March 13, 2012

COMMENTS ON THE CADIZ CONSERVATION, RECOVERY, AND STORAGE PROJECT DRAFT ENVIRONMENTAL IMPACT REPORT

Dr. Newsha Ajami
Pacific Institute
654 13th Street,
Oakland, CA 94612
510-251-1600
www.pacinst.org

Figure 1: Cumulative Annual Change in Groundwater Storage¹

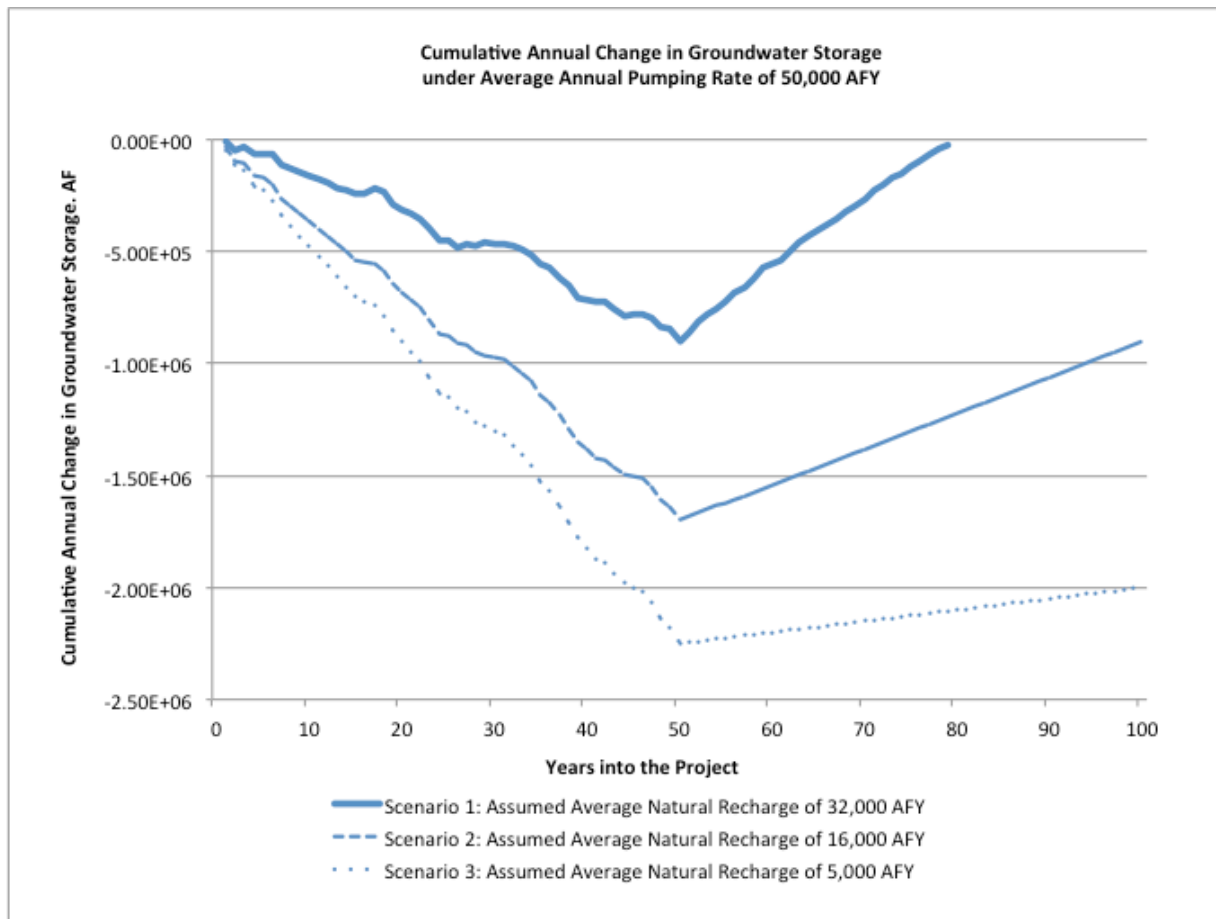
While groundwater levels can recover in some areas and under some conditions, groundwater overdraft raises two major concerns. First, the land might subside and collapse before the underground basin has a chance to refill and recover from overdrafting (Figure 1). Once the land subsides, the potential groundwater storage is permanently lost. They estimate that the cumulative land subsidence in various parts of the basin after 100 years is between 0.2-0.9 feet under Scenario 1 with a recharge rate of 32,000 AFY and between 0.7 and 2.7 feet under Scenario 3 with a recharge rate of 5,000 AFY (GEOSCIENCE Support Services Inc., Sep, 2011a). Second, overdraft can lead to saline water intrusion from surrounding areas. This degradation of the groundwater is a real possibility in this part of the Mojave Desert.

- The project would not have any NWS under the 16,000 AFY natural recharge rate by the end of the project term (50 years), because the proposed average pumping rate (50,000 AFY) will lead to overdrafting of the storage. The groundwater basin may need another 100 years to possibly deliver some net savings, if any (Figure 1).

- Under the 5,000 AFY recharge scenario, there will be no net water saving and the basin will suffer from a considerable and possibly unrecoverable state of storage depletion (Figure 1). Such overdrafting can cause intrusion of saline water from beneath the Dry Lakes playas into the fresh water aquifer and, as noted above, lead to land subsidence.
